# Access Compliance Report

## Public Rights-of-Way (Curb Ramps)

Intersection ID: 23801	Main Street: STEPHENDALE_DR	Cross Street: S_TRYON_ST	Location: SE
ADA ID: 0C241D46C469	Ramp Type: MedianPerp	Initial Pass/Fail: Fail	Overall Compliance: No
Severity Score: 22.5			
Codes/Mitigation Info/Possible Solution		Field Measurements/Component Compliance

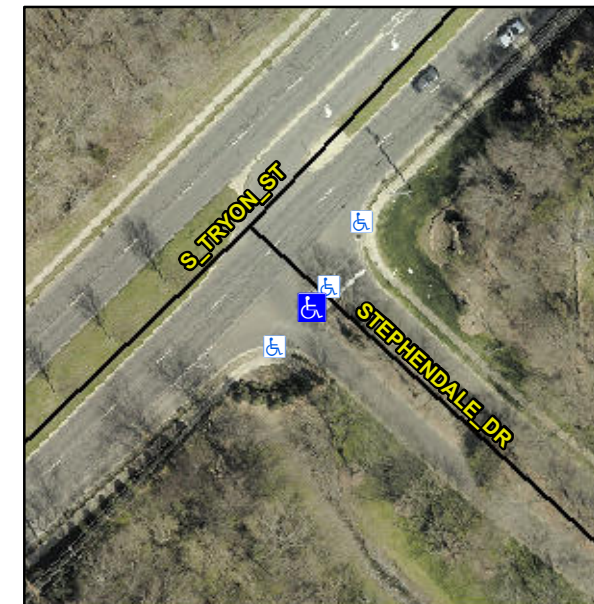
**Not Found, R304.5.1, R304.2.2**

Compliance	Description	Data	Compliance	Description	Data
N/A	Ramp Length (in)	81.0	No	Ramp Slope (%)	8.9
No	Ramp Width (in)	44.0	Yes	Ramp XSlope (%)	3.6
N/A	Flare Type LT	N/A	N/A	Flare Type RT	N/A
N/A	Flare Slope LT (%)	N/A	N/A	Flare Slope RT (%)	N/A
N/A	Flare Traversable LT?	N/A	N/A	Flare Traversable RT?	N/A
N/A	Landing Length (in)	N/A	N/A	DWS Provided?	N/A
N/A	Landing Width (in)	N/A	N/A	DWS Contrast?	N/A
N/A	Landing Slope (%)	N/A	N/A	DWS Length (in)	N/A
N/A	Landing X Slope (%)	N/A	N/A	DWS Full Width?	N/A
N/A	Landing Curb? (Y/N)	N/A	N/A	DWS Offset (in)	N/A
N/A	Shared Landing?	N/A			
N/A	Gutter Ponding?	N/A	N/A	Gutter Slope (%)	N/A
N/A	Gutter Lip Ht (in)	N/A	N/A	Gutter X Slope (%)	N/A
N/A	Painted X Walk1?	No	N/A	Painted X Walk2?	N/A
	X Walk 1 Direction	To SW		X Walk 2 Direction	N/A
N/A	X Walk 1 Width (in)	N/A	N/A	X Walk 2 Width (in)	N/A
	X Walk 1 Slope (%)	1.0		X Walk 2 Slope (%)	N/A
	X Walk 1 X Slope (%)	6.5		X Walk 2 X Slope (%)	N/A

**Remove & Replace Entire Ramp.**
